## ADDENDUM NO. 1

DATE: January 27, 2014

Contract 13-C-00042; Downs Pumping Station Rehabilitation – Sheltered market

Downs Pump Station Location

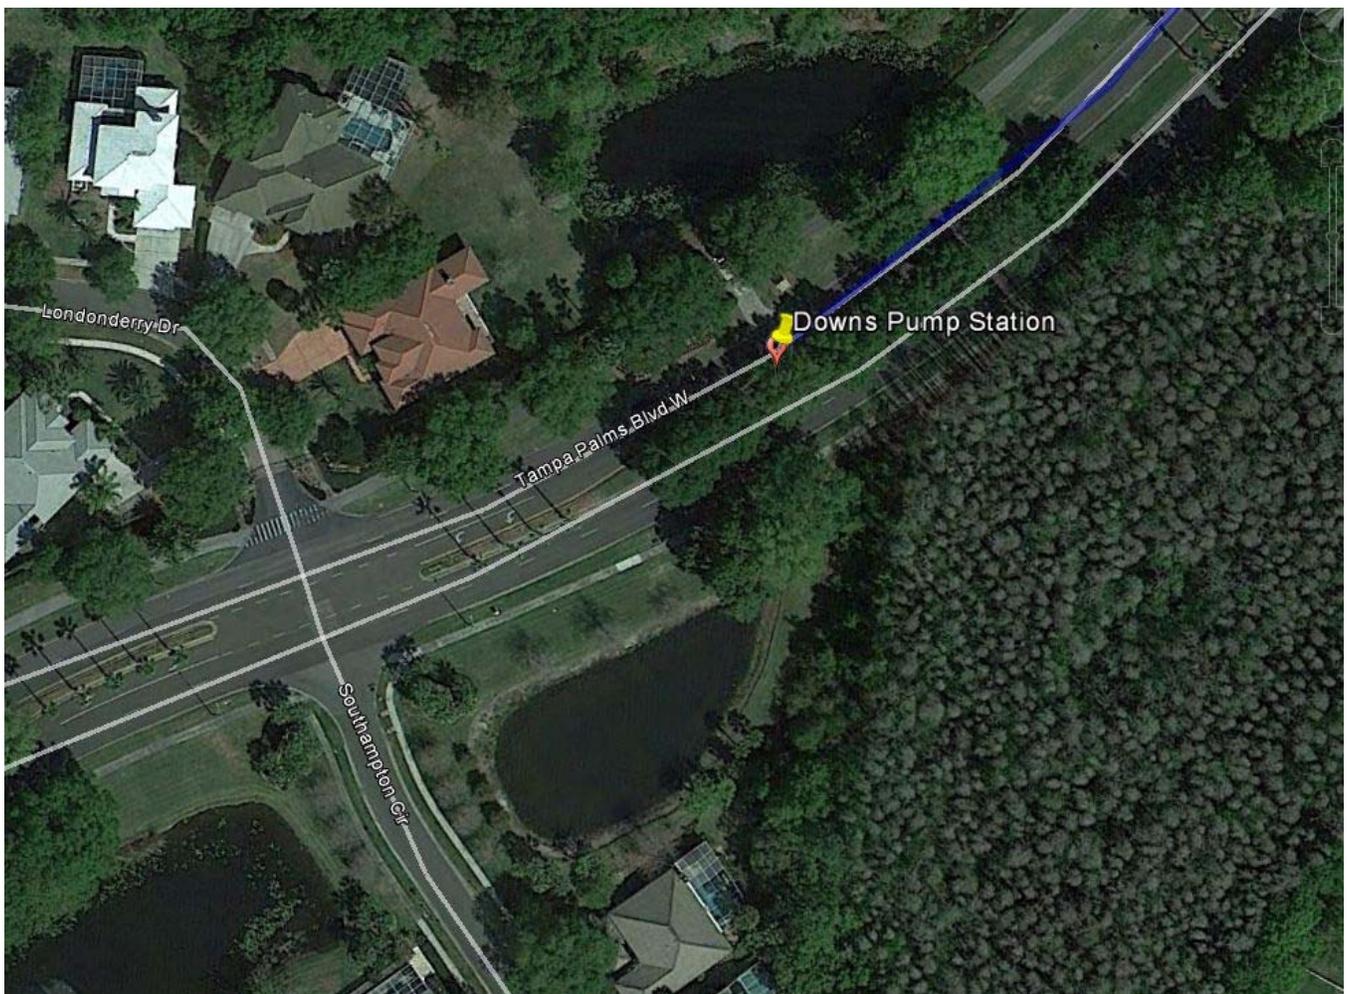
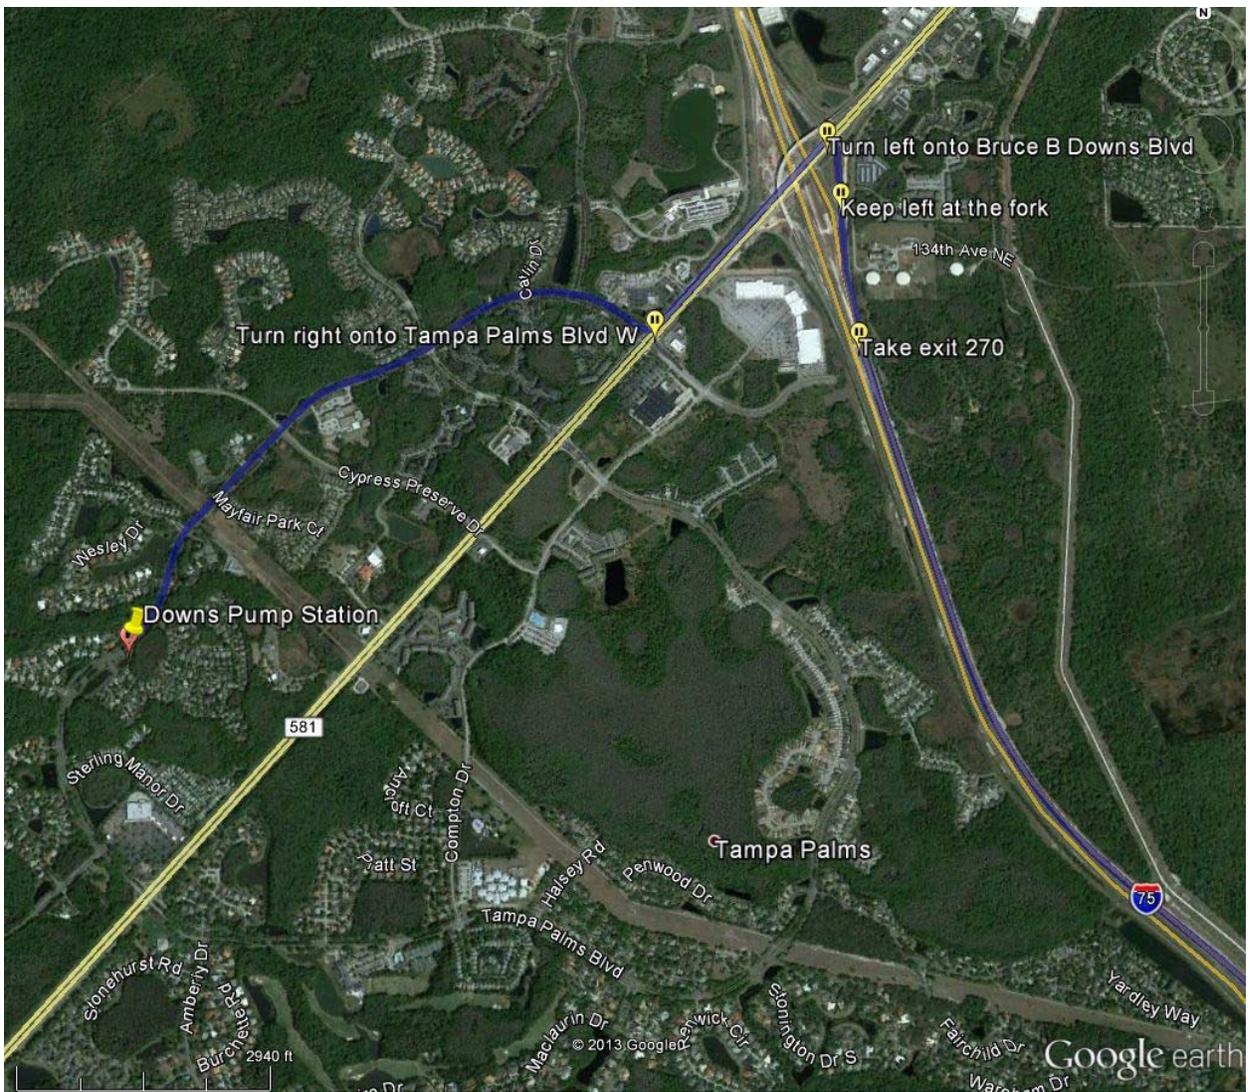
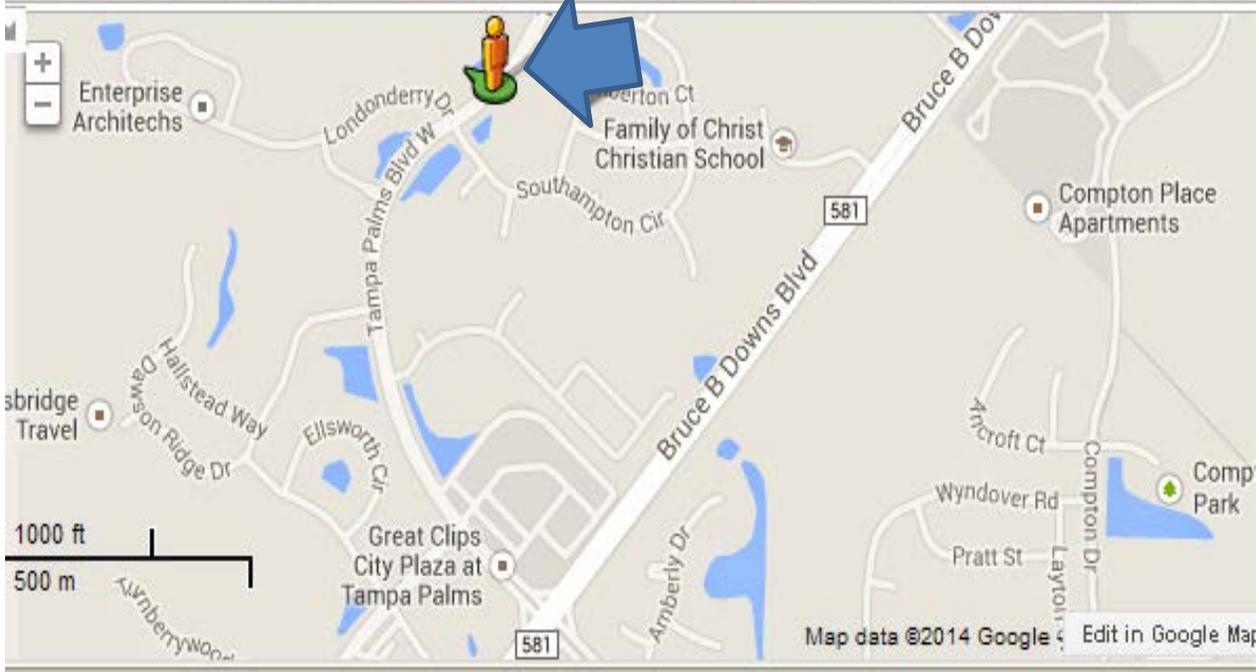
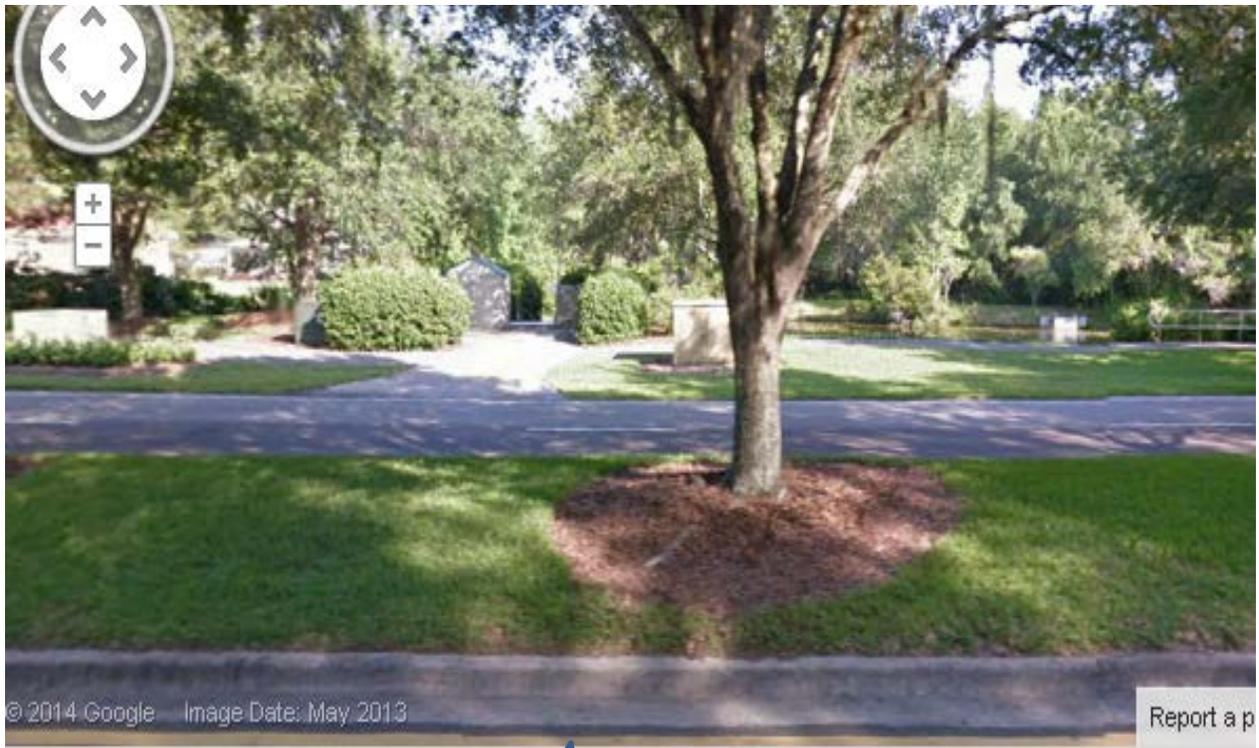
- Item 1: Pump Station location clarification: the address listed in the bid documents is incorrect. Refer to the attached maps for the correct pump station location.
- Item 2: Replace Workmanship and Materials Sub-section 46.09 Sewage Pump Controller/SCADA/Radio (PCSR) with the attached, revised Workmanship and Materials Sub-section 46.09
- Item 3: Replace Plan Sheets E11 and E14 with the attached, revised plan sheets E11 and E14.

Tampa Palms Blvd W, East of Londonderry Dr.
